FAIRFAX COUNTY

STAFF REPORT

APPLICATION RZ 1998-SU-009

**FINAL DEVELOPMENT PLAN
FDP 1998-SU-009**

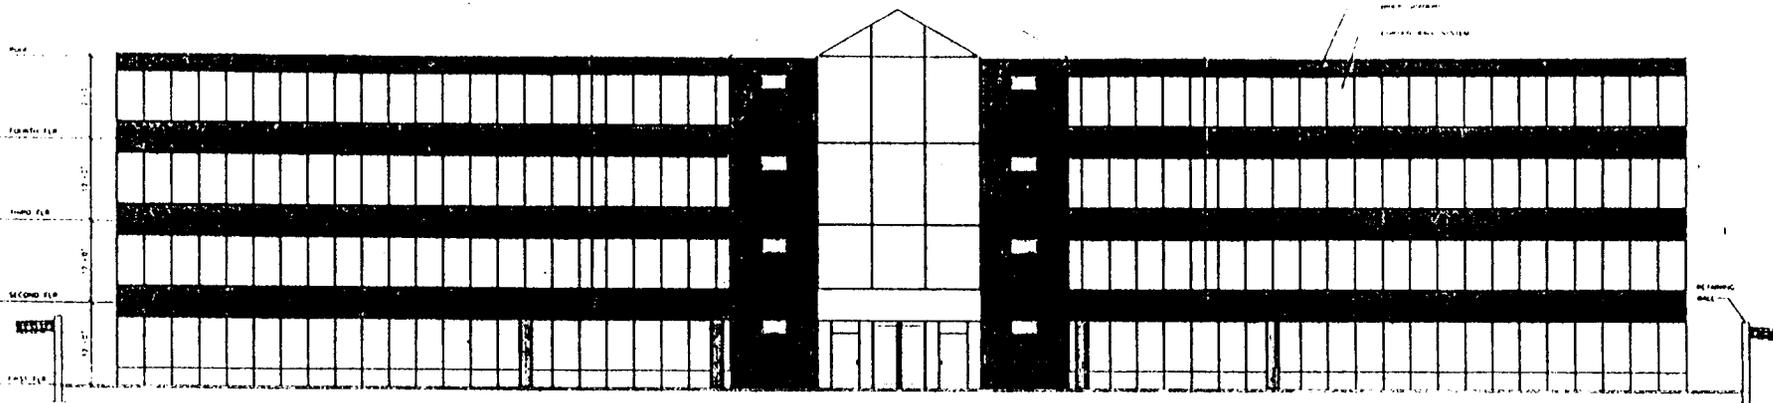
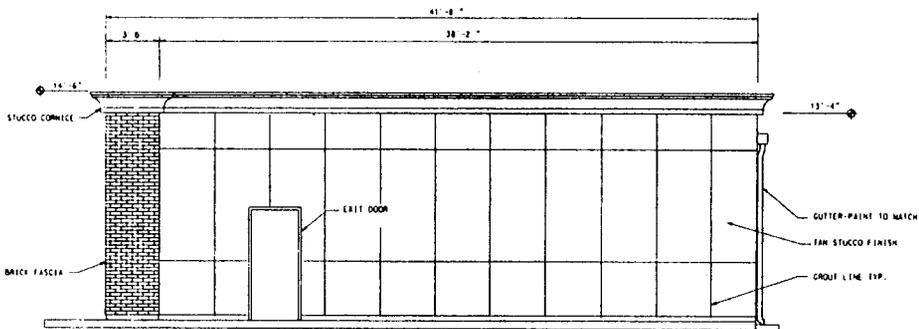
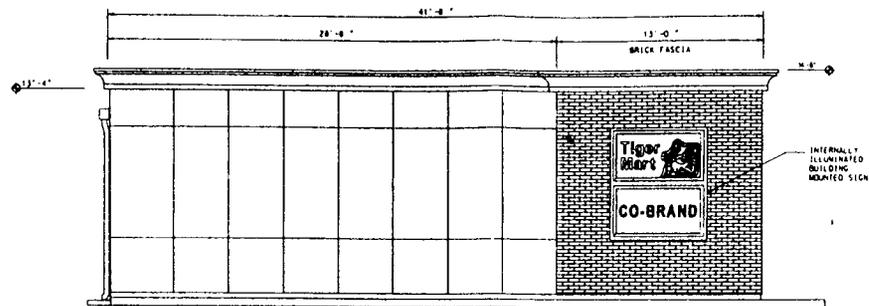
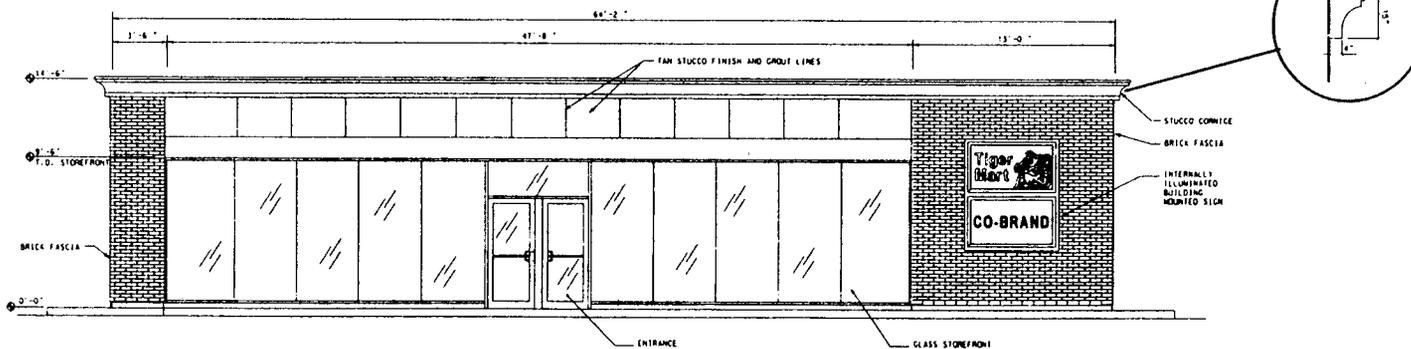
Integration and high quality design are requirements to develop at the overlay level as this application requests. The revised development plan depicts architectural schematics which show architectural details for the proposed hotel, office and service station structures. Integration of the design of the service station with the rest of the project would be improved if it is designed with a pitched roof which would reflect a design detail of the proposed hotel to the north.

CONCEPTUAL ELEVATIONS
EXXON STATION 2-0199
FAIR RIDGE DRIVE & I-66 JACKSON MEMORIAL HWY RYE SO
CENTREVILLE DISTRICT
FAIRFAX COUNTY, VIRGINIA

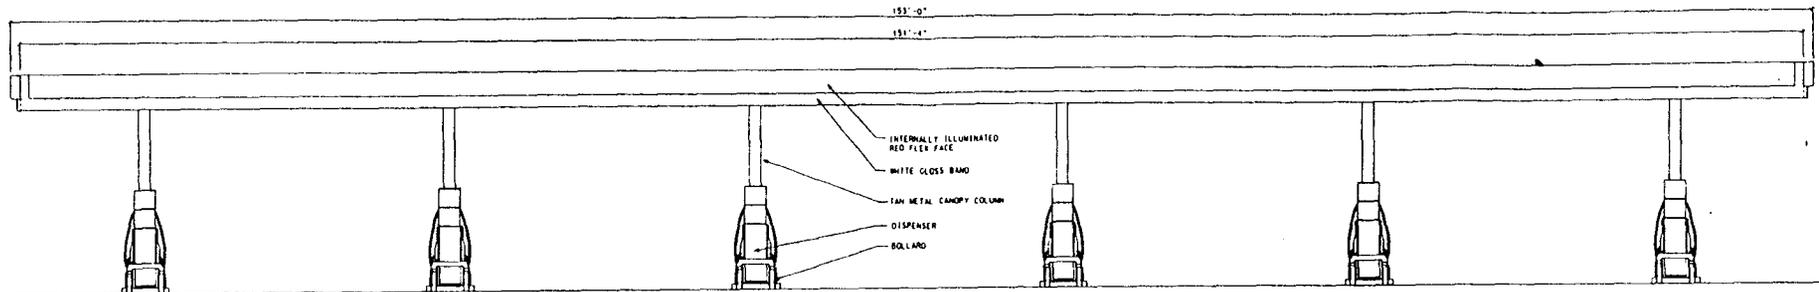
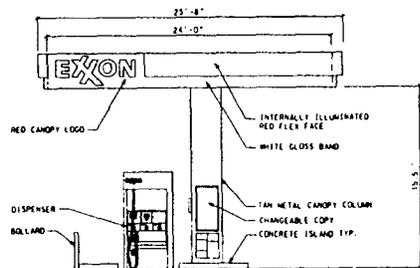
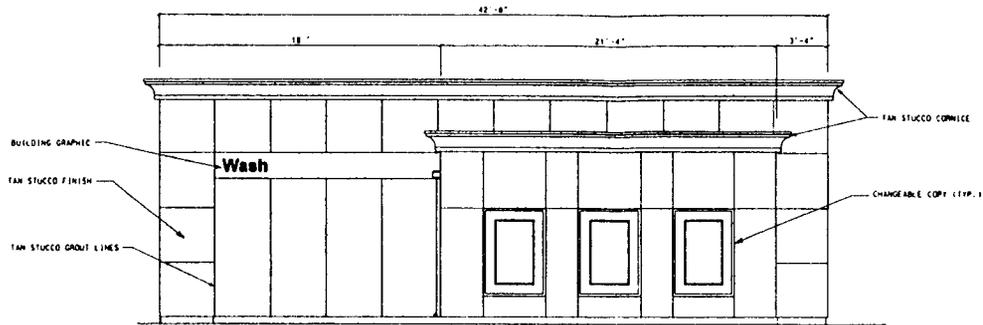
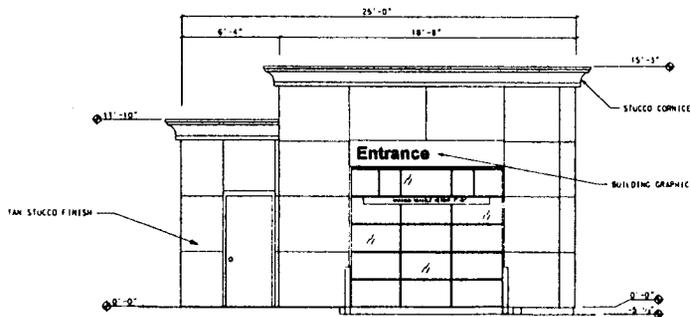
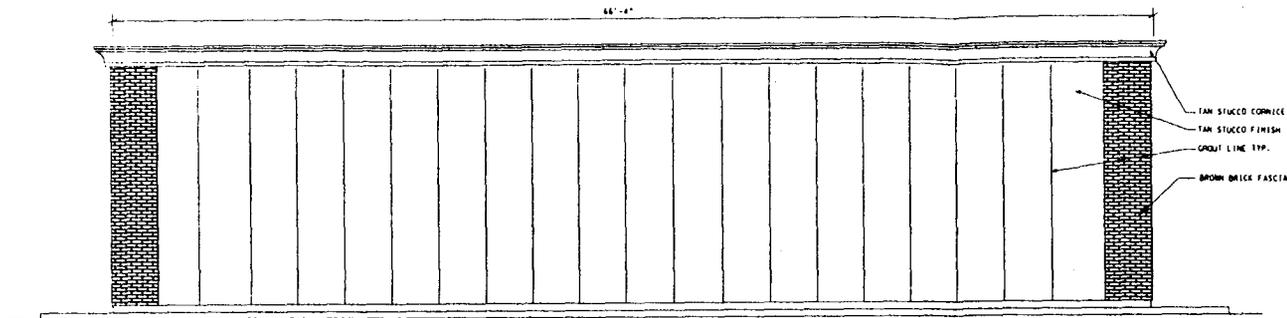
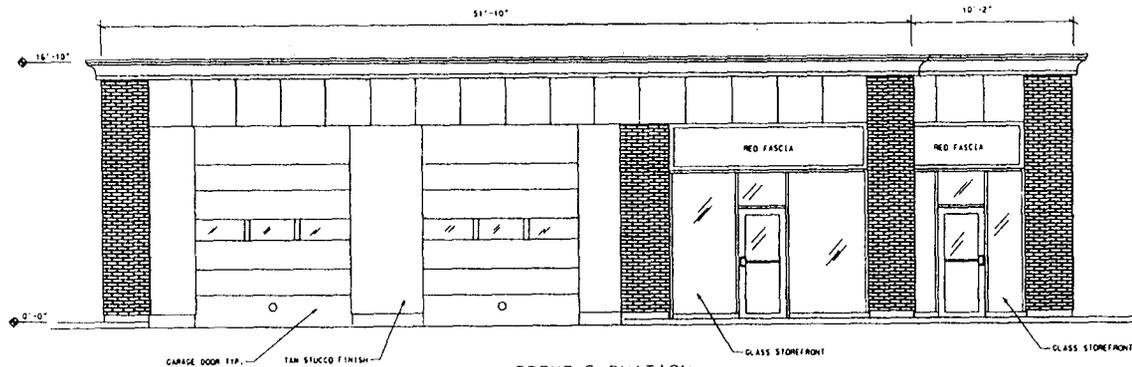
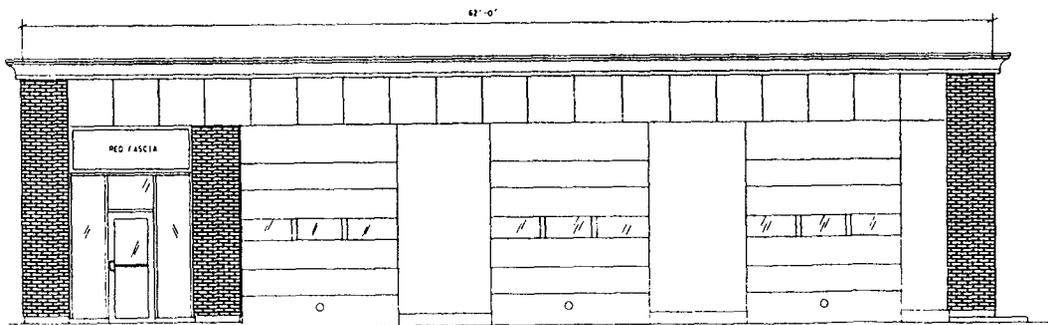
The applicant should provide a comprehensive sign and lighting plan for the whole site, including the service station. A monument sign would be more appropriate than the pole sign proposed for the service station.
